February 16, 2010

**Comments on the Validation of the Jiangxi Xinchang
2x660MW Ultra-Supercritical Project**

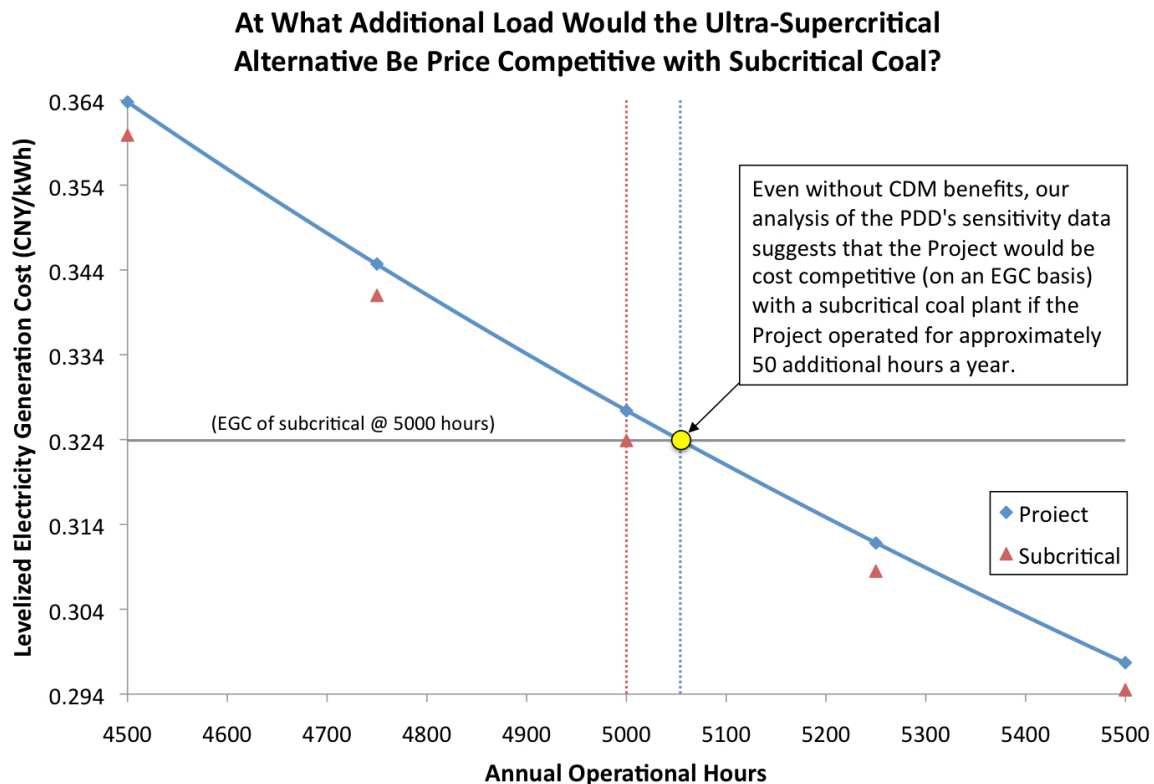
Looking at project participants' sensitivity analysis, we can see that the ultra-supercritical (Project) alternative would be more financially viable than the subcritical alternative if the ultra-supercritical plant were to operate at a five percent higher load per year.⁴⁶ Under China's dispatch rules, a five percent differential in plant loads could be possible. Furthermore, project participants have considered load sensitivity only in five percent increments, so the PDD does not reveal the exact loading differential needed to achieve price competitiveness between the alternatives.

Our further analysis, based on the PDD's sensitivity data, suggests that cost competitiveness could actually be achieved at a load differential of only one percent. As shown in the figure below, the ultra-supercritical plant would only need to operate for about 50 more hours (i.e., one percent of the assumed load of 5000 hours) a year to be cost competitive with the subcritical plant. This differential is possible and perhaps probable under China's dispatch rules. The DOE must challenge project participants' assumptions regarding plant loads.
